LVD Timing Diagram Correction

Thoughts for late May SPI-3 meeting

SPI-3R5 Figure 44 & 45 correction

-Figure 44

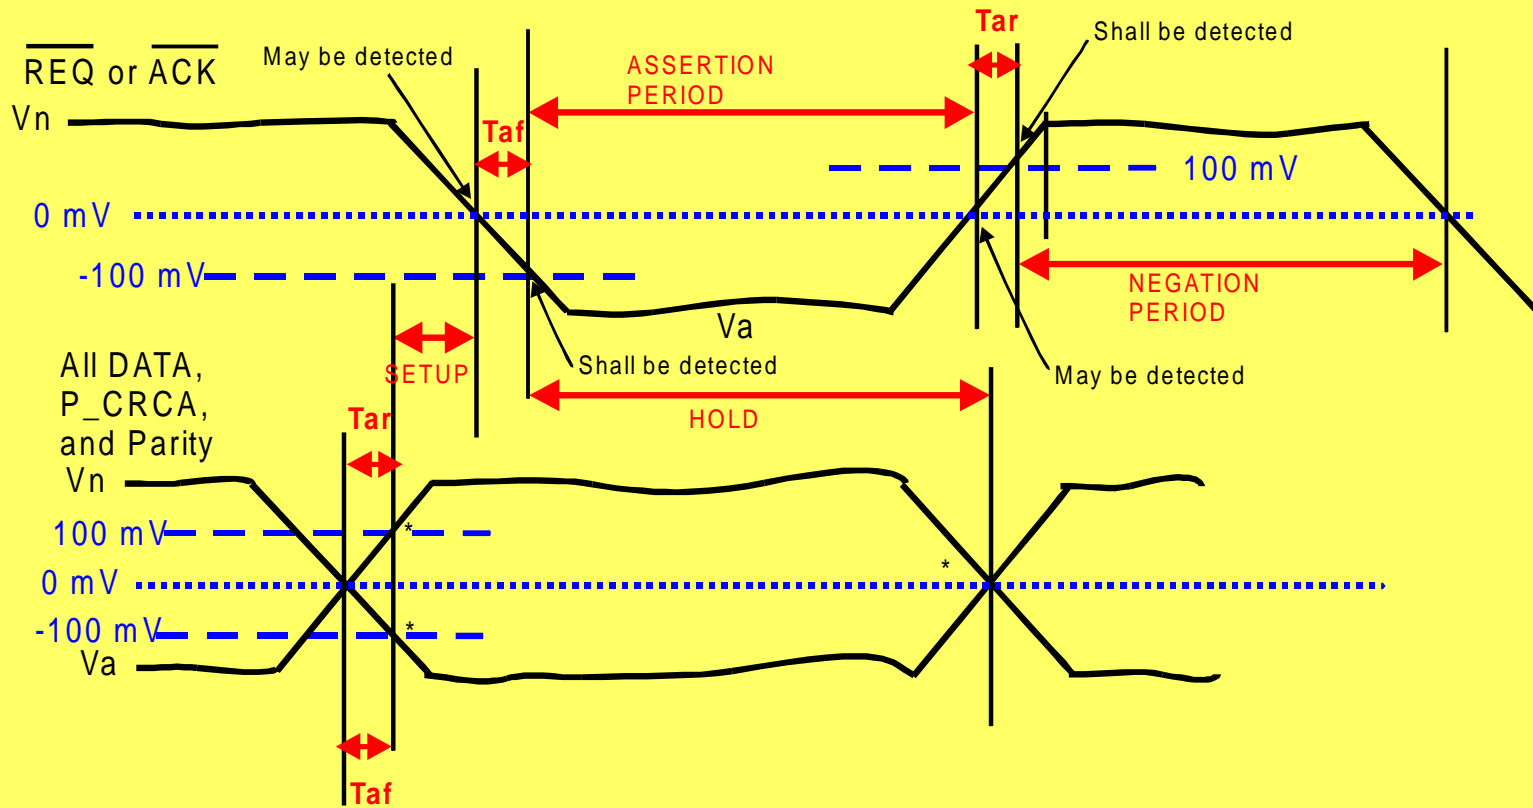
Proposed changes to the LVD ST Timing Diagrams

* Use the crossing that yields the shorter SETUP and HOLD Time
 V_a or V_n must drive the 100 mV threshold at the leading edge of the transition.
 V_n = Negated Signal
 V_a = Asserted Signal
 Differential voltage signals in all Cases

T_{af} and T_{ar} must be less than 2 ns and any signal structure while in the T_{af} or T_{ar} region including slope reversal may occur.

-Figure 45

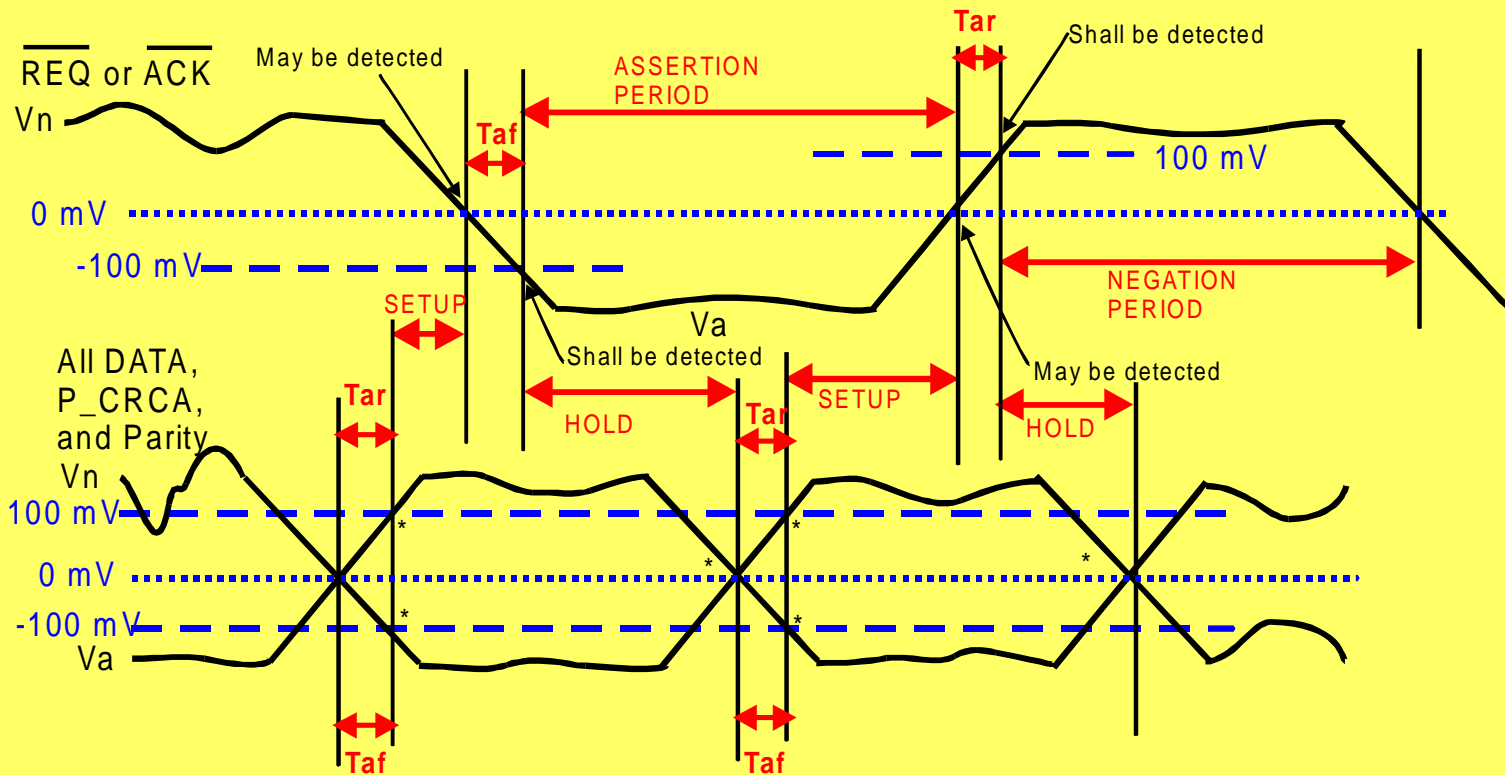
* Use the crossing that yields the shorter SETUP and HOLD Time
 V_a or V_n must drive the 100 mV at the leading edge of the transition.
 V_n = Negated Signal
 V_a = Asserted signal
 Differential voltage signals in all Cases

T_{af} and T_{ar} must be less than 2 ns and any signal structure while in the T_{af} or T_{ar} region including slope reversal may occur. (At the receiver)

Proposed changes to the LVD DT Timing Diagrams
